Access Compliance Report

Public Rights-of-Way

(Curb Ramps)

Intersection ID: 11727	Main Street: W_8TH_ST	Cross Street: N_POPLAR_ST	Location: S
ADA ID: 2D04E93C43DA	Ramp Type: PerpDiag	Initial Pass/Fail: Fail	Overall Compliance: No
Severity Score: 13.75			
Codes/Mitigation Info/Possible Solution		Field Measurements/Component Compliance

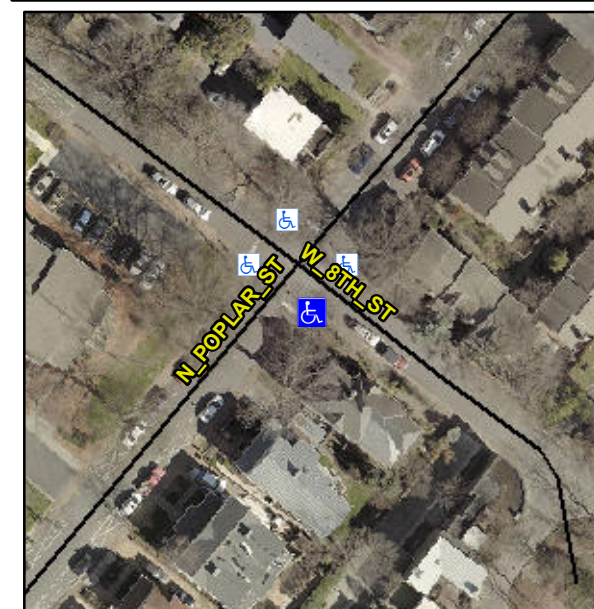
Not Found, R304.2.2, R304.5.3

Compliance	Description	Data	Compliance	Description	Data
N/A	Ramp Length (in)	31.0	No	Ramp Slope (%)	11.4
Yes	Ramp Width (in)	48.0	No	Ramp XSlope (%)	3.2
N/A	Flare Type LT	N/A	N/A	Flare Type RT	N/A
N/A	Flare Slope LT (%)	N/A	N/A	Flare Slope RT (%)	N/A
N/A	Flare Traversable LT?	N/A	N/A	Flare Traversable RT?	N/A
N/A	Landing Length (in)	N/A	N/A	DWS Provided?	N/A
N/A	Landing Width (in)	N/A	N/A	DWS Contrast?	N/A
N/A	Landing Slope (%)	N/A	N/A	DWS Length (in)	N/A
N/A	Landing X Slope (%)	N/A	N/A	DWS Full Width?	N/A
N/A	Landing Curb? (Y/N)	N/A	N/A	DWS Offset (in)	N/A
N/A	Shared Landing?	N/A			
N/A	Gutter Ponding?	N/A	N/A	Gutter Slope (%)	N/A
N/A	Gutter Lip Ht (in)	N/A	N/A	Gutter X Slope (%)	N/A
N/A	Painted X Walk1?	No	N/A	Painted X Walk2?	No
	X Walk 1 Direction	To NE		X Walk 2 Direction	To NW
N/A	X Walk 1 Width (in)	N/A	N/A	X Walk 2 Width (in)	N/A
	X Walk 1 Slope (%)	4.2		X Walk 2 Slope (%)	7.1
	X Walk 1 X Slope (%)	6.7		X Walk 2 X Slope (%)	1.8

N/A	Ramp inside XWalk1?	N/A	N/A	Ramp inside XWalk2?	N/A
	Road Slope (%)	0.3	N/A	Clear Space?	N/A
	Road X Slope (%)	4.6	N/A	Clear Space to XWalk (in)	N/A
N/A	Any Obstructions?	N/A	N/A	Storm Grate/Utility Hazard?	N/A
	Obstruction Type			Storm Grate/Utility Type	
		N/A			N/A
		Yes		Surface Condition? (G/P)	Good

Remove & Replace Curb Ramp With Two New Directional Ramps or Equivalent.
